Application Serial No.: 09/987,035
Art Unit: 2632

Attorney Docket No. 6730.03
Confirmation No. 6584

Amendments to the Drawings:

Fig. 5

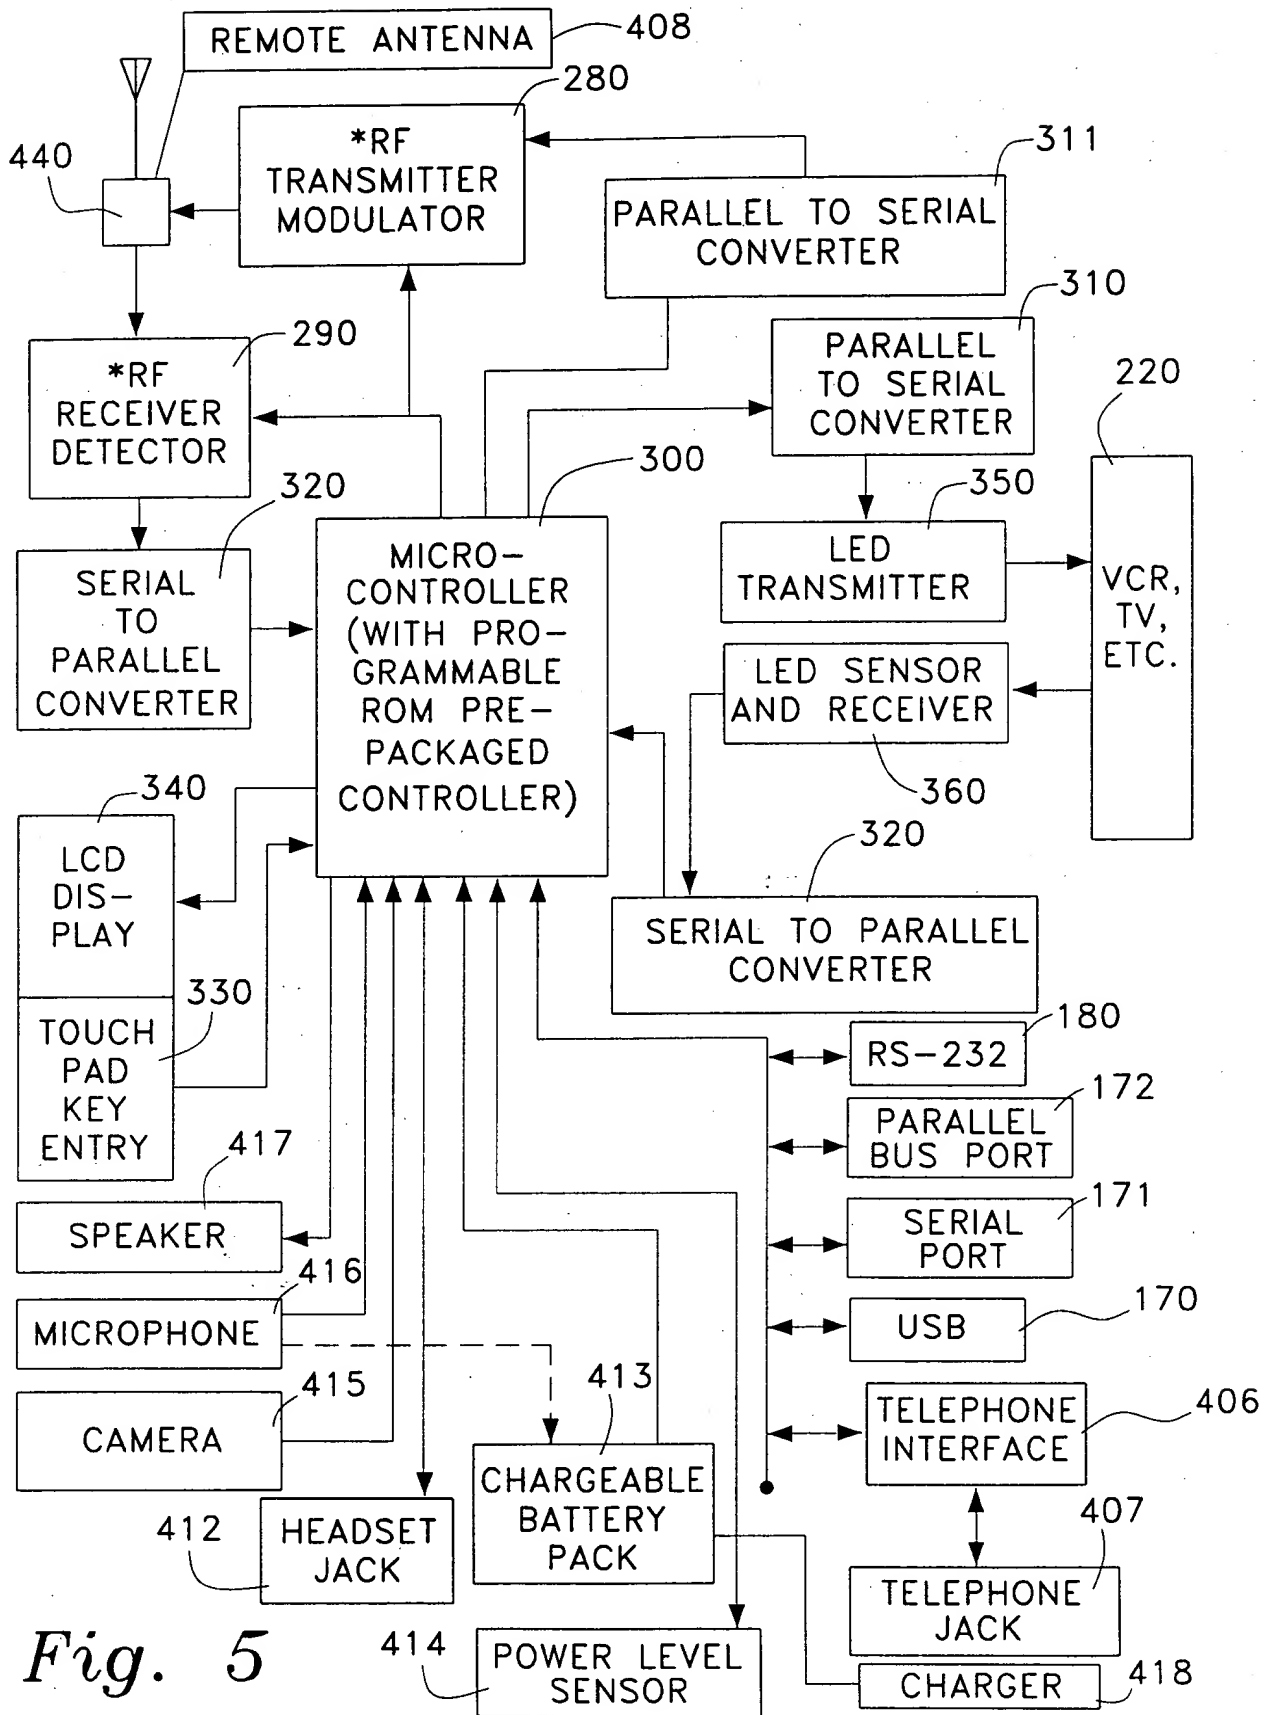
A proposed drawing change is submitted herewith. Proposed changes are shown in red. The attached sheets of drawings include changes to Figs. 5, 6, and 9. These sheets replace the original sheets of Figs. 5, 6 and 9. In Figs. 5, 6, and 9, reference numeral ~~440~~—designating the frequency detector and discriminator element has been added.
